**20-DDP-0047**  
**105 Rochester Dr**

**Louisville Metro Development Review Committee**

**Jay Lockett, AICP, Planner I**  
**October 14, 2020**

**BAE Expansion**  
105 Rochester Drive  
Louisville, Kentucky 40214  
Tina R. & D. Louisville II, LLC  
Louisville, Kentucky 40214

BAE EXPANSION LANDSCAPE AND SCREENING EXHIBIT

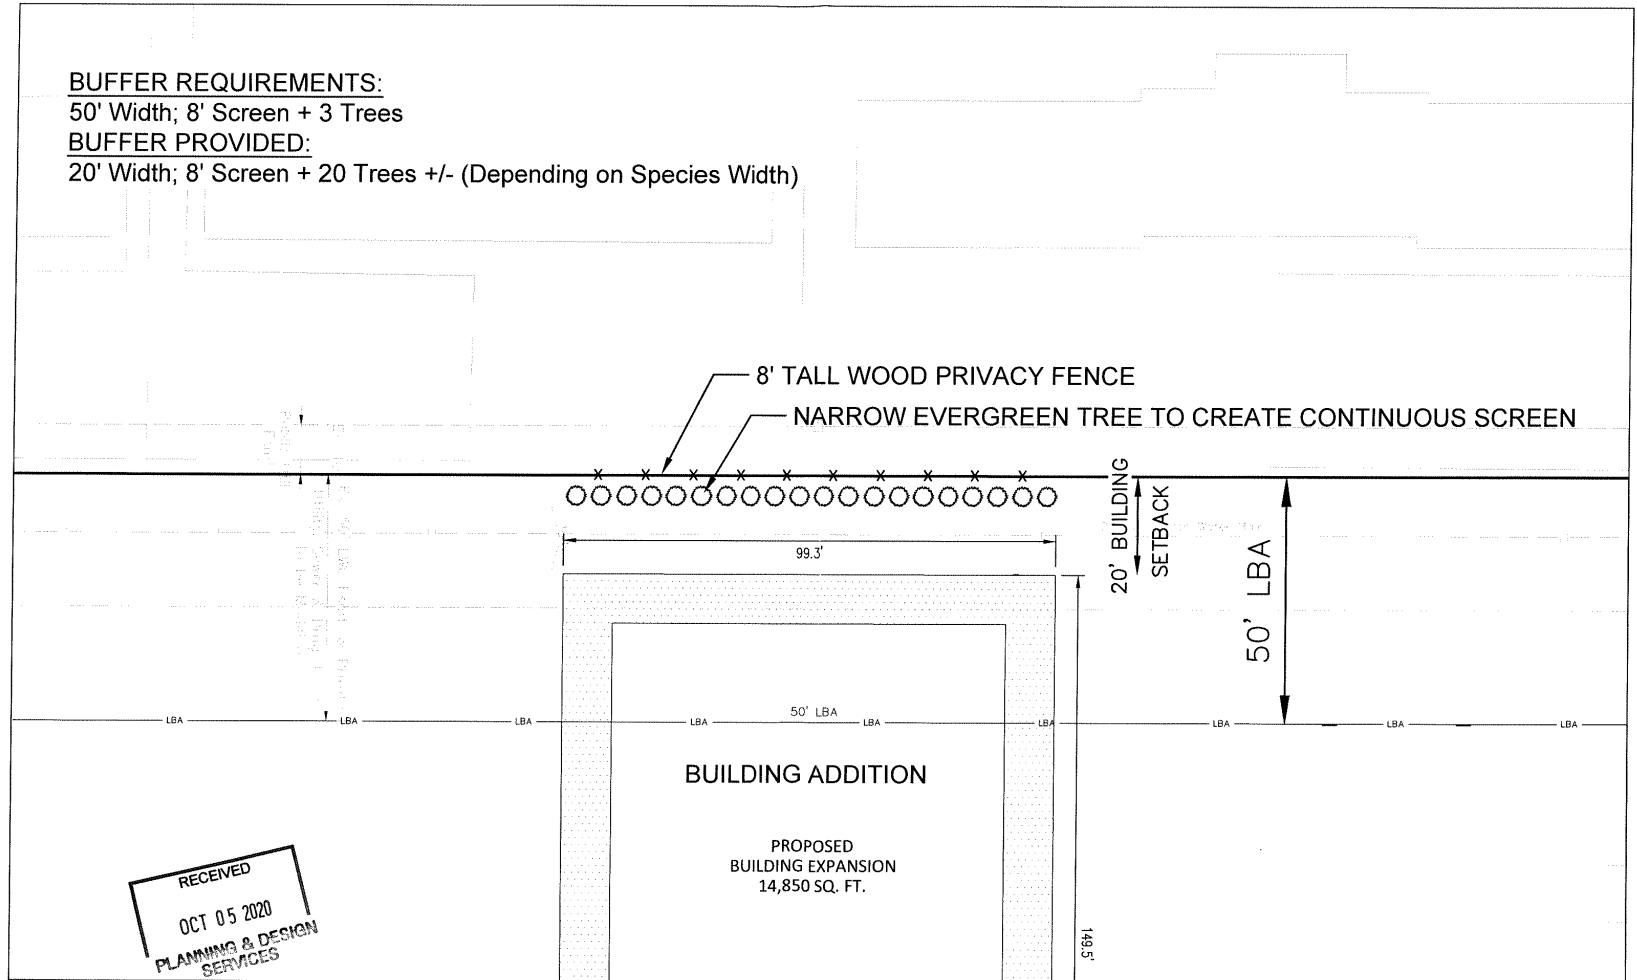
**Waiver** of Land Development Code sections 5.5.4.B.1, 5.7.1 and 10.2.4 to encroach into the required 50' property perimeter landscape buffer area.

## BUFFER REQUIREMENTS:

50' Width; 8' Screen + 3 Trees

## BUFFER PROVIDED:

20' Width; 8' Screen + 20 Trees +/- (Depending on Species Width)

8. The applicant shall provide screening as shown on the landscaping exhibit presented to the Development Review Committee on October 14, 2020. The final location and type of trees shall be shown on the approved landscape plan and chosen in conference with Planning and Design Services staff landscape architect.
